**Re: Lot 15 Block 2 Unit 19 Volcano Cliffs SAD 228
6508 Camino Del Oeste NW
Request Permanent C.O. – Accepted
Engineer's Stamp dated: 11-28-17 (D10D003G15)
Pad Certification dated: 12/4/17
Certificate of C.O. dated: 6/7/18**

DRAINAGE AND TRANSPORTATION INFORMATION SHEET (REV 09/2015)

RE: **Lot 15 Block 2 SAD 228**
Volcano Cliffs Subdivision
6508 Camino Del Oeste NW
Grading and Drainage Plan
Engineers Stamp Date 11/28/17 (D10D003G15)
Pad Certification Date: 12/4/17
CO Certification Dated: 6/7/18

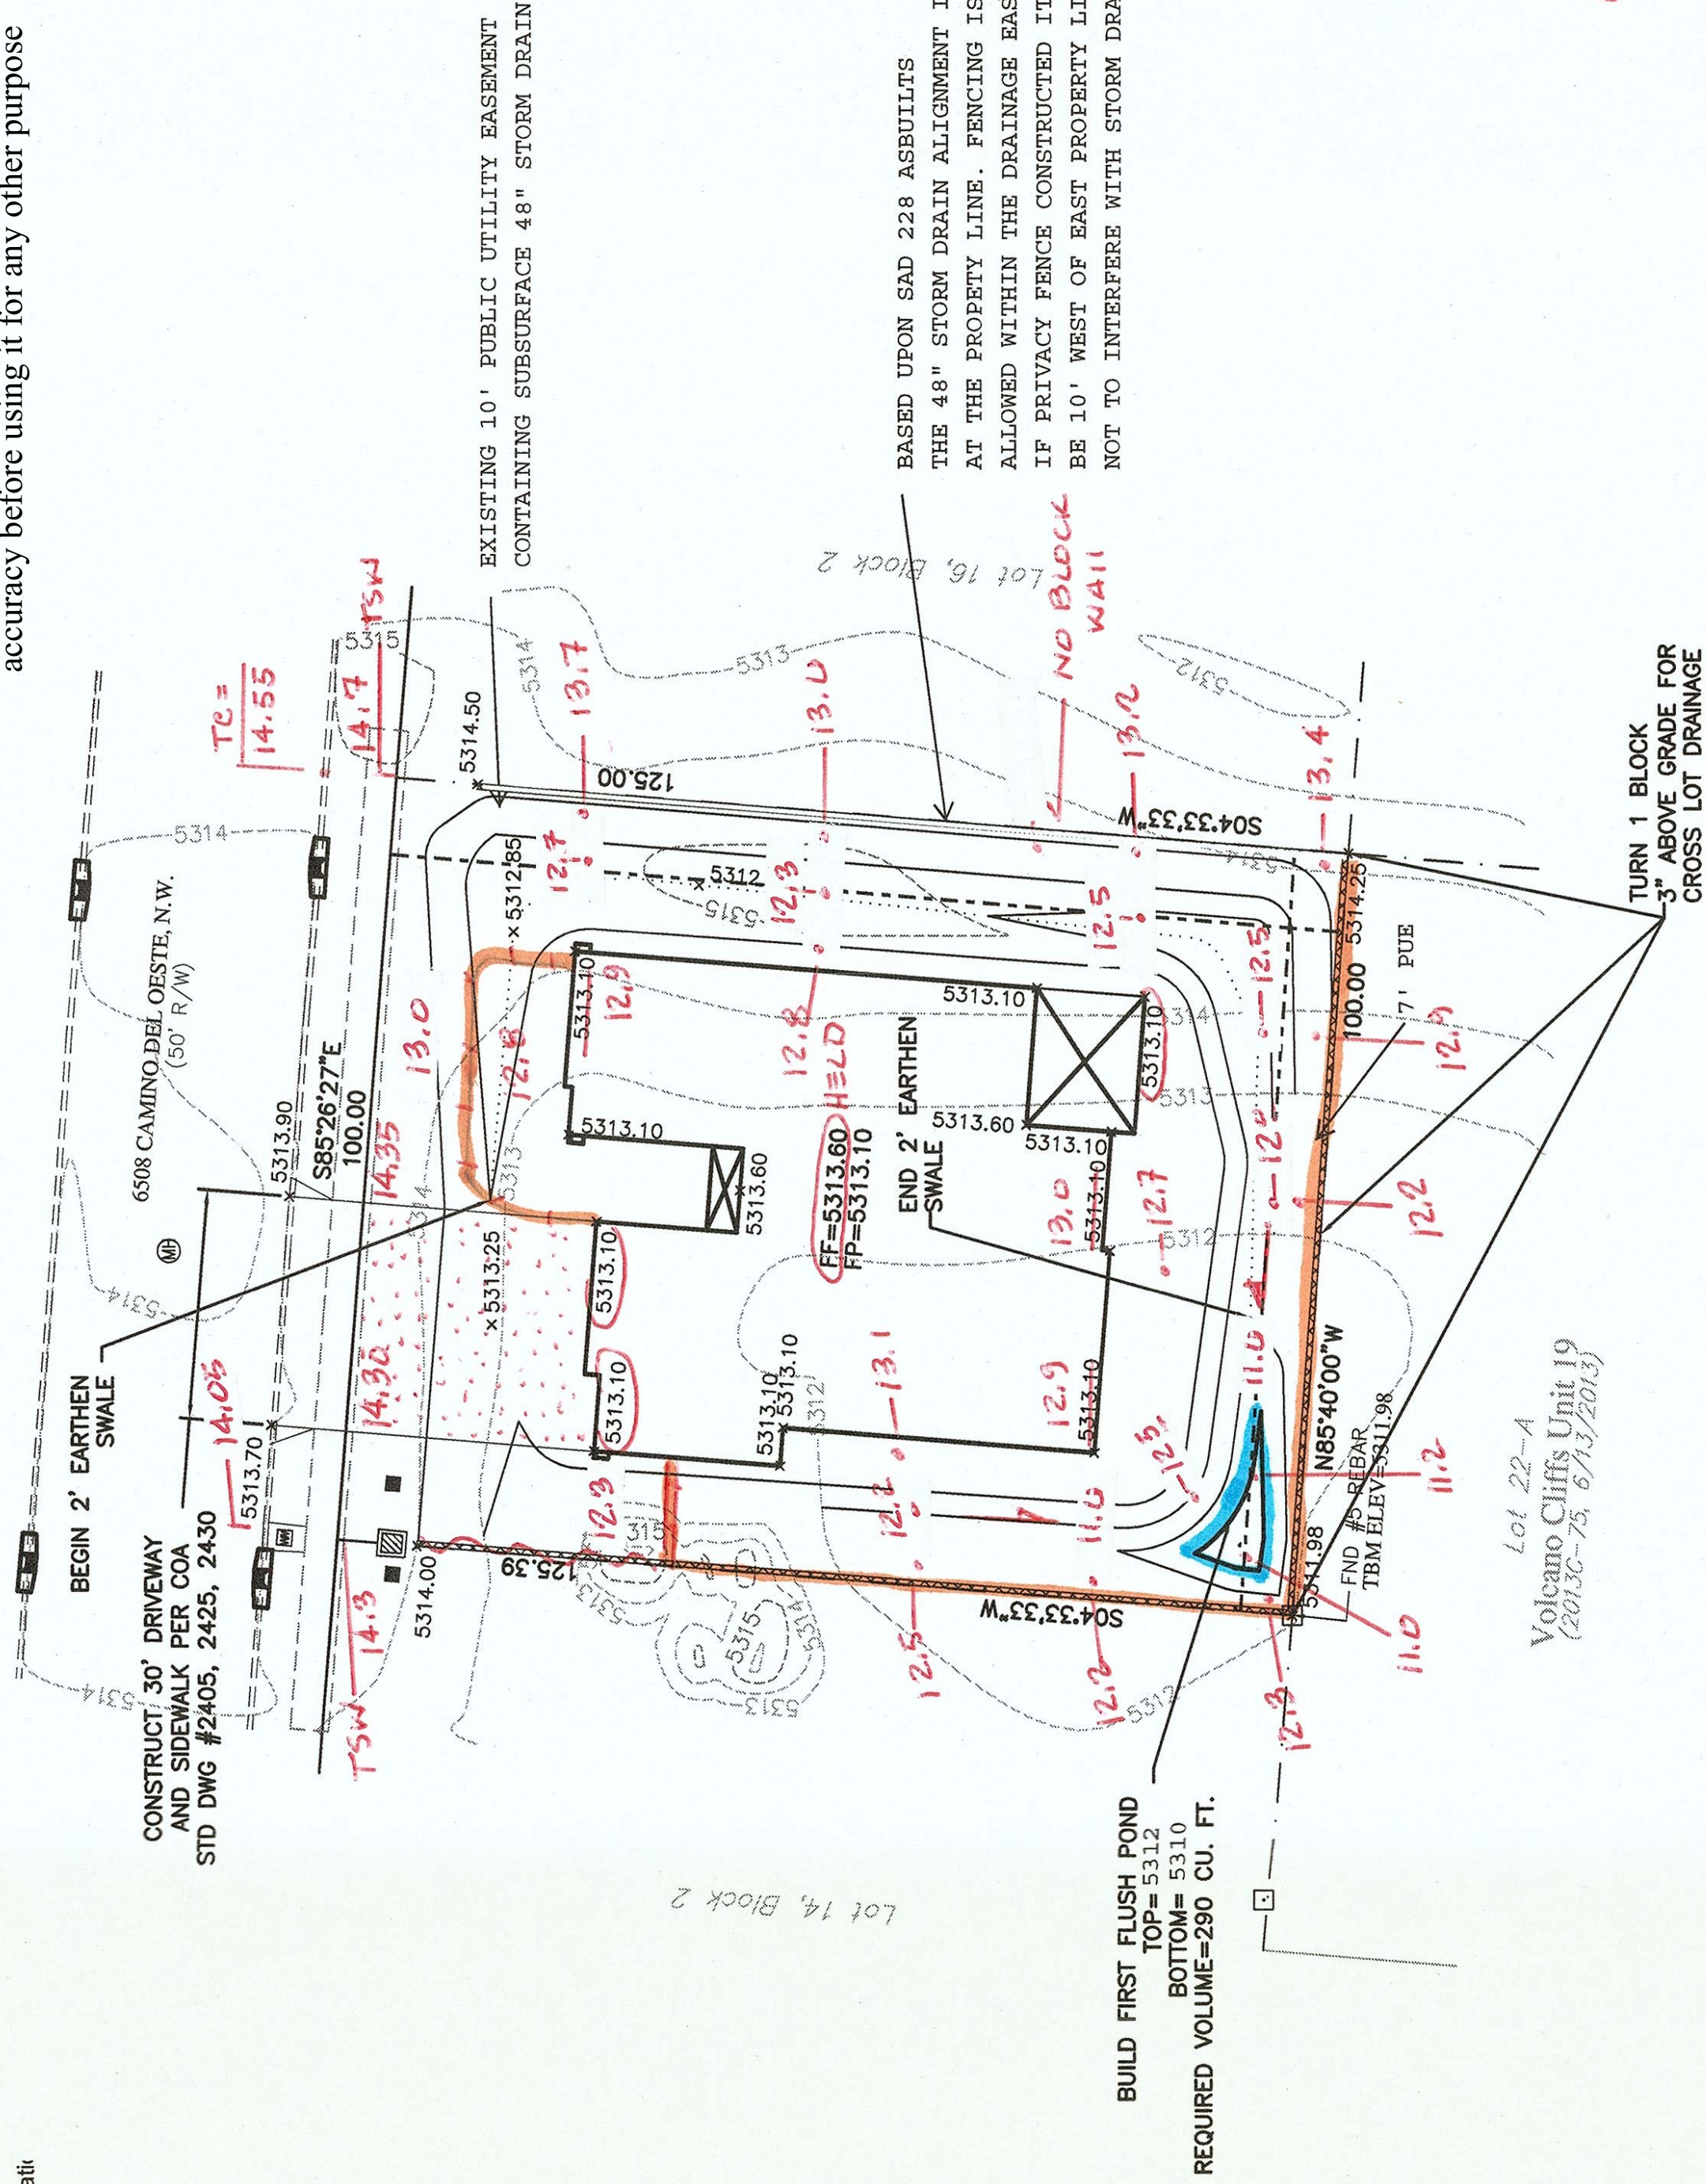
Based upon the information provided in your submittal received 6/7/18, this plan cannot be approved for Certificate of Occupancy until the following comments are addressed.

- Remove the concrete slabs in the public right of way.
- Remove all concrete and debris in and around the site.
- Remove the gravel in the street.
- Provide turn blocks as noted on the approved plan.
- Provide opening in front yard garden wall where swale is located.
